Product Change Notification / KSRA-18BGHS695

CCB 4559 Initial Notice: Qualification of SIGN as a new assembly site for selected SST39LFxxxx and SST39VFxxxx device families available in 48L TSOP (12x20mm) package.

CCB 4559
Pre and Post Change Summary
PCN # KSRA-18BGHS695

Lead frame Comparison

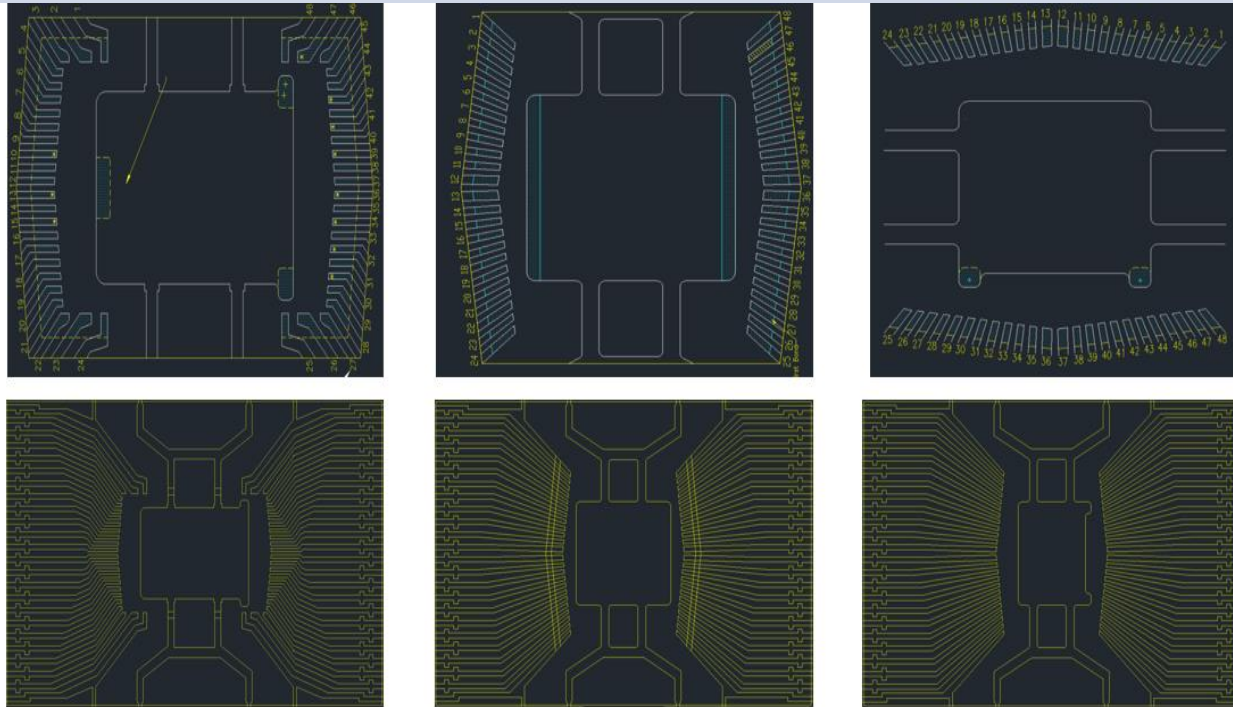
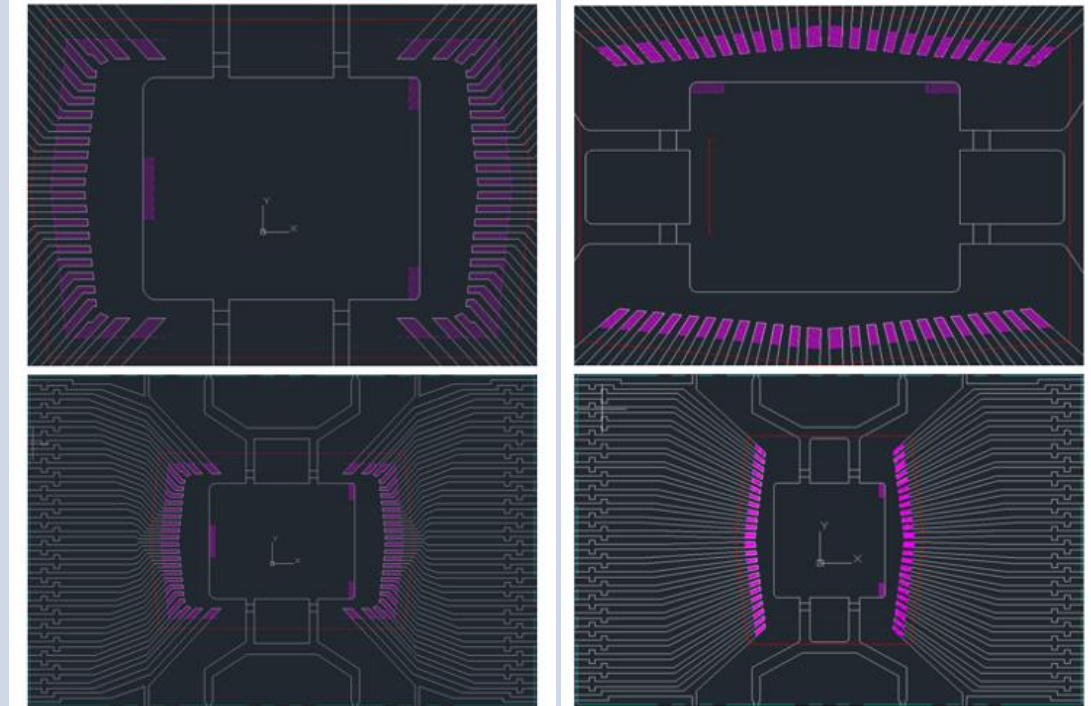
Bond Wire material	Au			Au	
Die Attach material	8340			AP-4300	
Mold compound material	G700			G700	
Lead frame material	C7025			C7025	
DAP Surface plating	Ring plating			Double ring plating	
Lead frame paddle size	207x142mils	183x161mils	160x130mils	209x165mils	159x165mils
	See attached pre and post change comparison
